Subject: ISX15 CM2350 Fuel Pump Tappet ATC for HOGAN

Number: Atc1958

Date: 27-Oct-2017

Figure 1: Tappet guide plug, floating pin, and the tappet roller with guide slot.

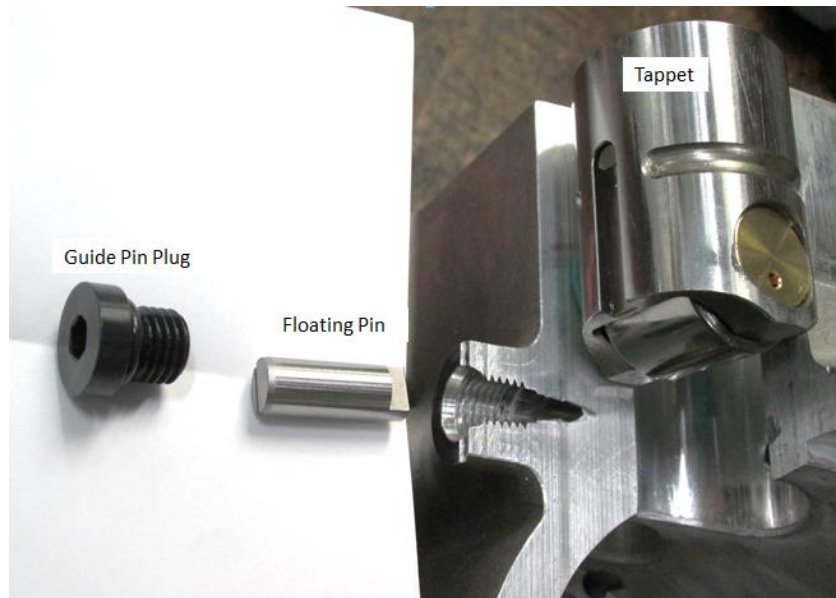
Warning! Tappet Guide Pin May Rotate

The tappet guide pin is a floating pin and plug design, as shown in Figure 1 below. The floating pin has a rectangular end that engages the groove on the tappet. Refer to Figures 2 and 3. The pin can be rotated by hand. Be certain the pin engages the tappet properly before installing the fuel pump head.

- NOTE:** Warning! The tappet guide pins may rotate during the removal of the tappet. The tappet cannot be correctly installed if the tappet guide pin is out of position. Please refer to Attachment B for the proper orientation of the tappet guide pin.
